**TOPICAL RESPONSE 2: LIGHTING**

This topical response is provided due to the number of commenters that raised questions on lighting including intensity of lights, frequency/duration of use, and dark sky impacts.

Terrain Cross-Sections and Line-of-Site View Profile from Receptor T within Malibu Bluffs Recreation Area

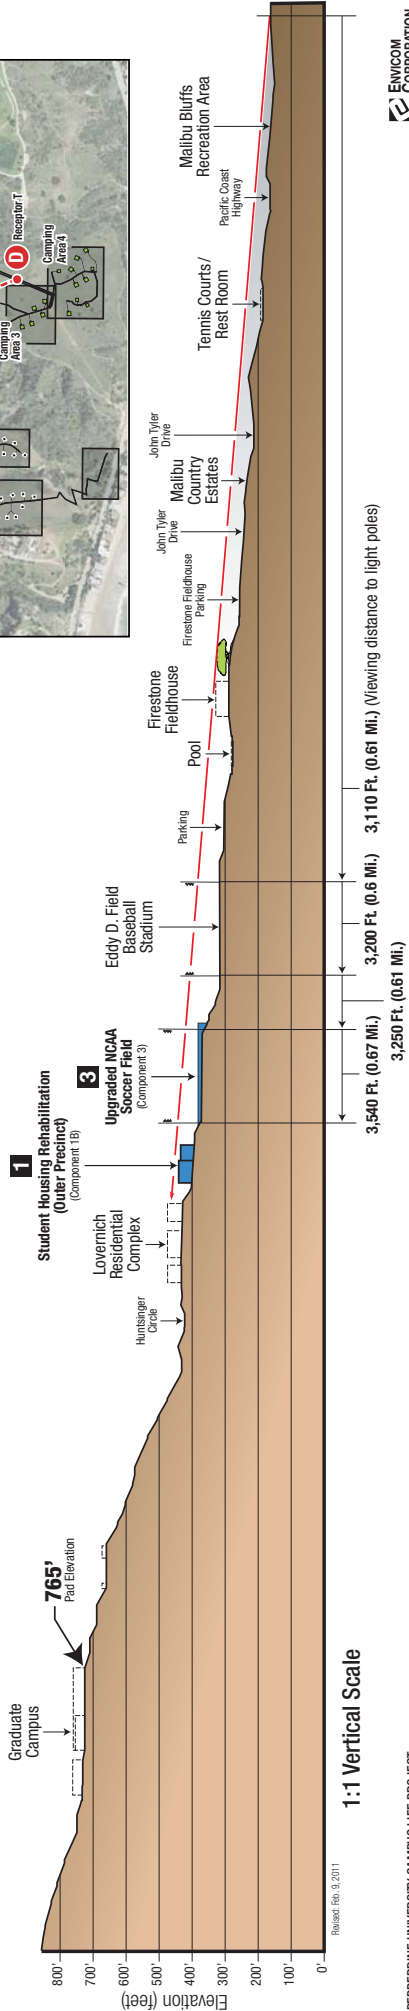
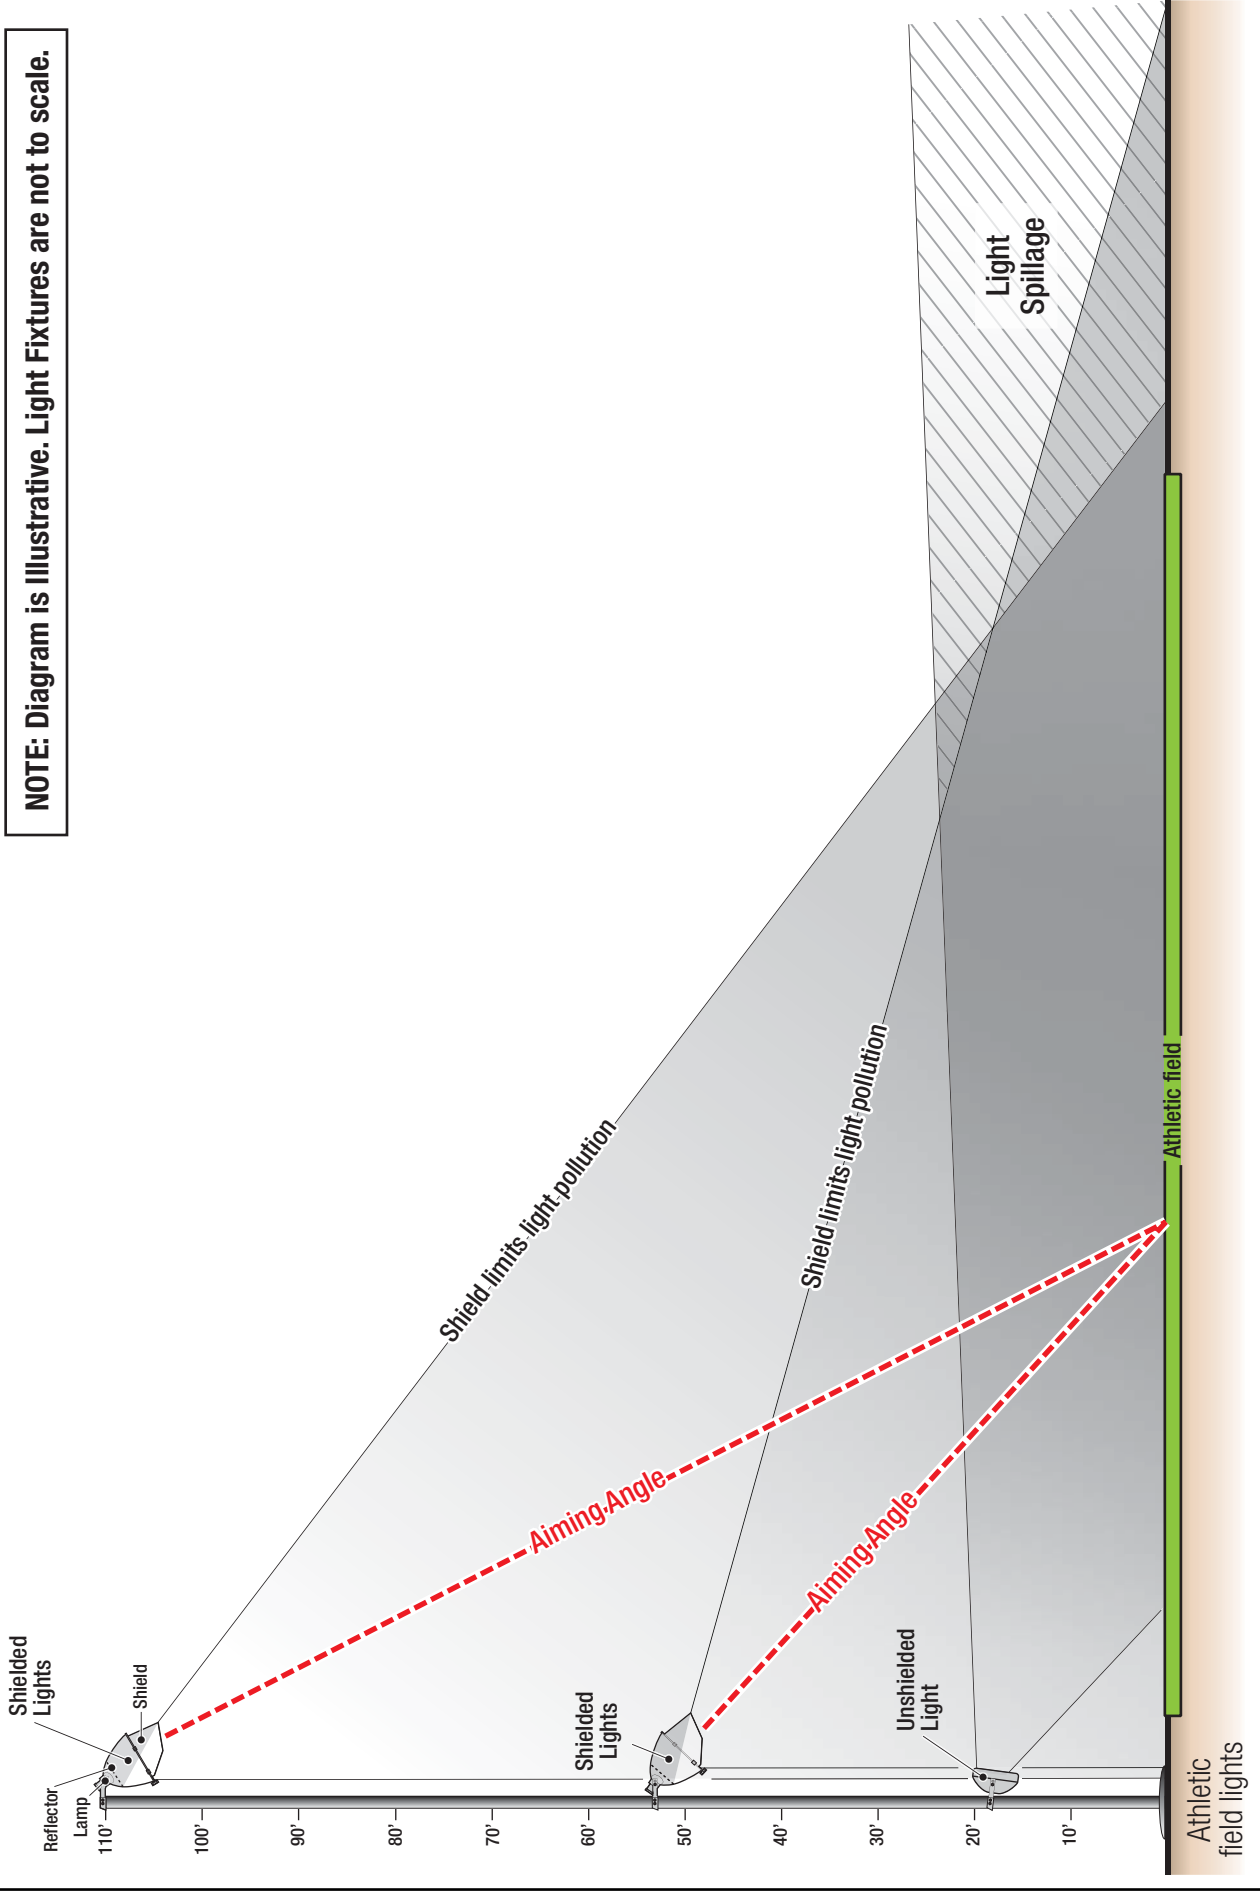
Other commenters expressed concerns that the CLP’s sports lighting would be visible from Malibu Bluffs. View study analysis has shown that the CLP Athletic lighting fixtures will be visible from Site Receptor Site T (see **Figure 1**). However, because the fixtures (or luminaires) are fully shielded and aimed downward, the light sources (lamps) will not be visible from Receptor Site T. As shown in **Figure 2**, the proposed pole heights are designed to enable steep aiming angles that reduce light trespass and glare impacts. Further, this design approach is most sensitive to concerns related to sky glow and coincides with the recommendations to reduce or mitigate sky glow provided by the International Dark Sky Association (IDA) and IESNA. Additionally, the implementation of Mitigation Measure 5.7.2-6 ensures that poles that are visible to the general public will incorporate exterior textures and color coatings that will blend with prevailing background colors and textures.

Receptor Site "T" is situated on a trail that leads from a proposed parking area to campsites in Camping Areas 3 and 4. Receptor Site "T" has a higher elevation than any of the campsites and the view from it represents the "worst-case" view of Component 3 from anywhere within the Malibu Bluffs Recreation Area.

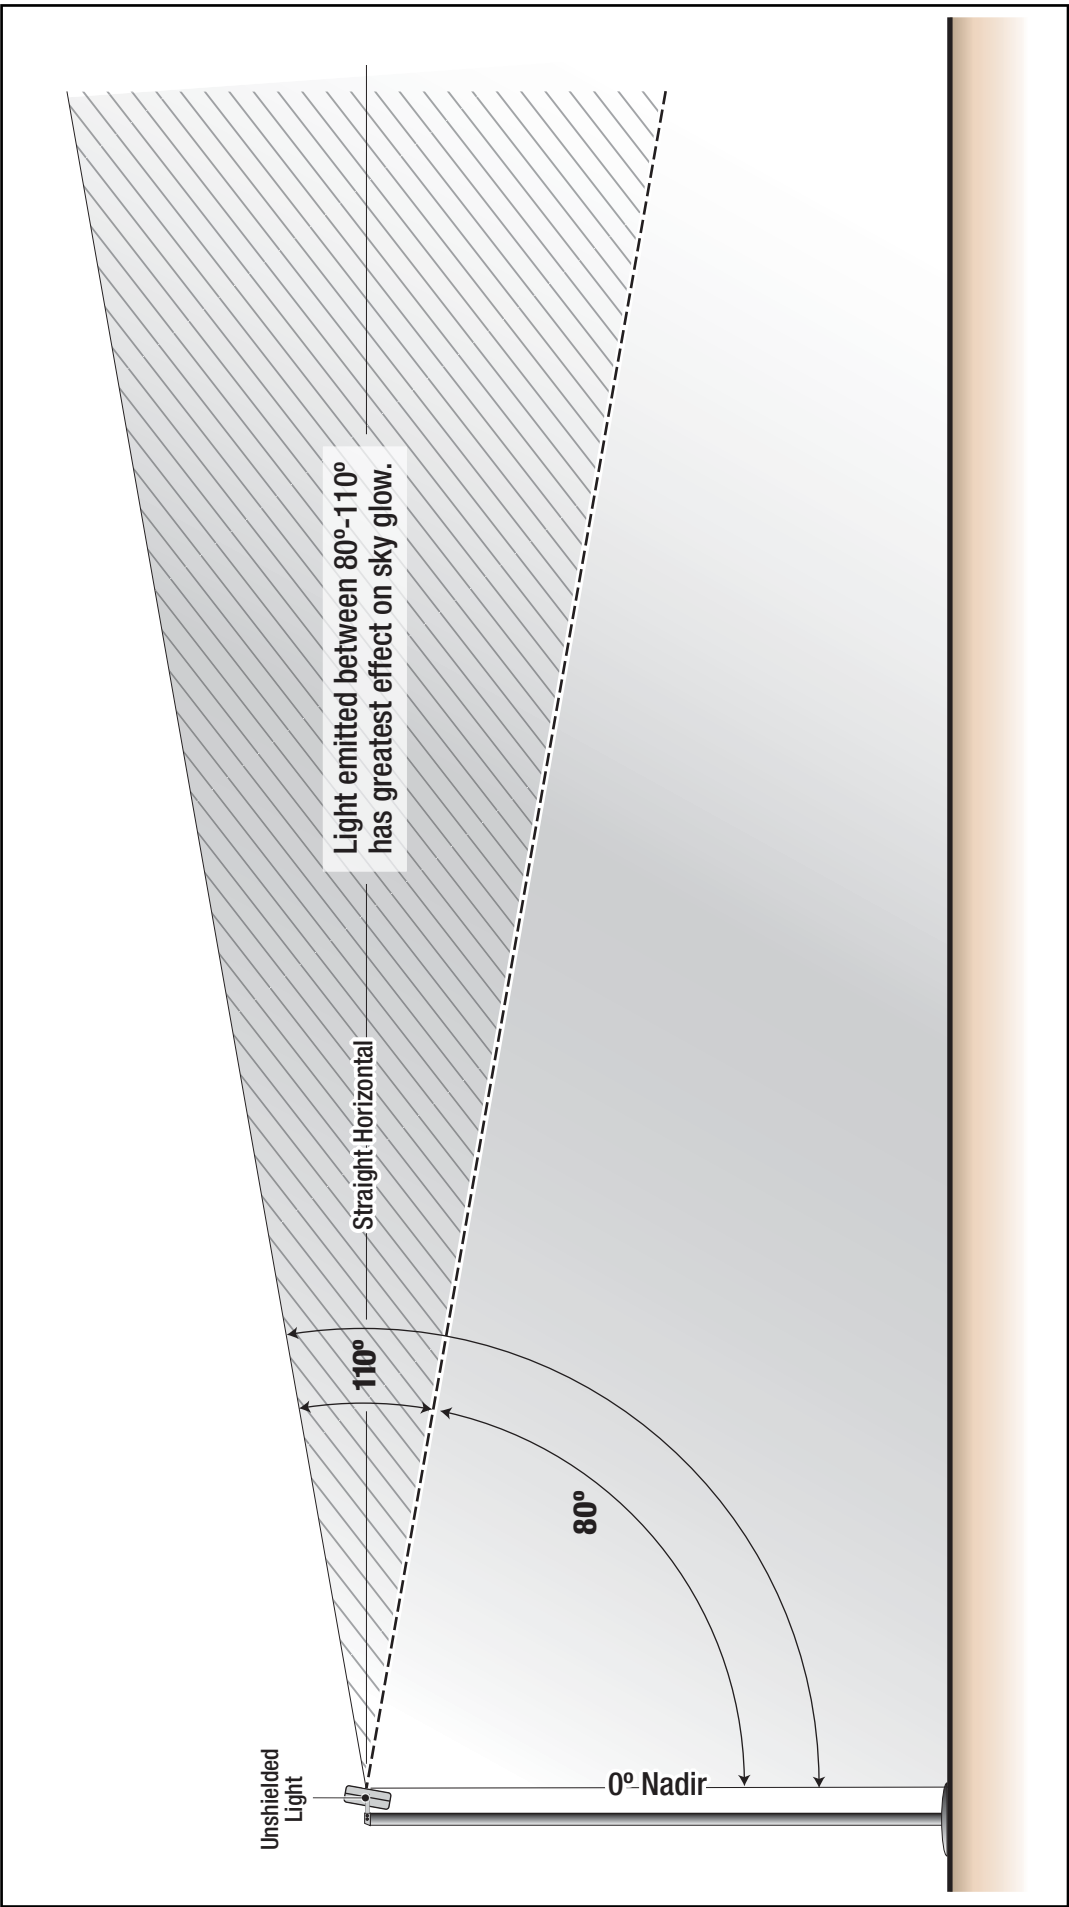
Light that results in sky glow is redirected back to the ground as a result of the initial angle of light and the presence of particulates and aerosols within the atmosphere. As shown in **Figure 3**, light emitted between 80 and 100 degrees from nadir<sup>8</sup> has the greatest effect on sky glow where it is most aerosol dependent. Light emitted at these angles has a greater effect in rural areas in which buildings do not

obstruct the light emitted at these angles. Light emitted between 0 and 80 degrees is far less likely to result in sky glow because the light travels downward towards the ground rather than horizontally into the sky.
